**ZONING CHANGE REVIEW SHEET**

CASE: C814-2018-0121 -- 218 South Lamar

TO: PUD

ADDRESS: 218 South Lamar Boulevard Southbound

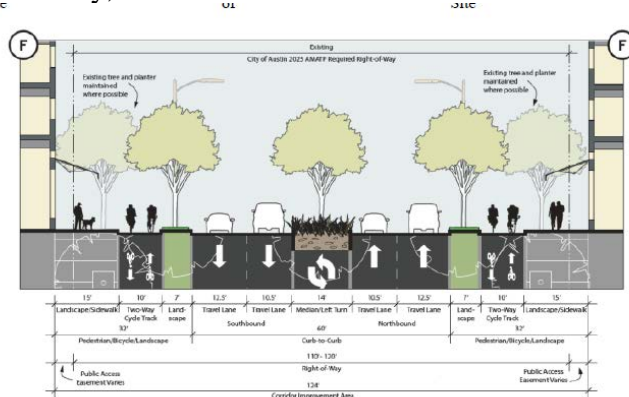
TR2. Include the below streetscape in the land use plan. Contact this reviewer for a more legible copy of it if necessary. This project is adjacent to a street that has been identified in Austin's Corridor Mobility Program (S Lamar). The sidewalk and bicycle facilities shall comply with the required cross-section at the time of the site plan application. The cross section that will be required is shown below. Find additional information about the Corridor Mobility Program here: <https://data.austintexas.gov/stories/s/Corridor-Mobility-Program/gukj-e8fh/>. Any proposed curb relocations on S Lamar requires coordination with the Corridor Planning Office and Bicycle Program. The cross section will include a 7' planting zone with street trees, a 10' two-way cycle track, and a 15' clear zone all behind curb. Additionally, a protected intersection will be required at Toomey, to be reviewed at the time of Site Plan.
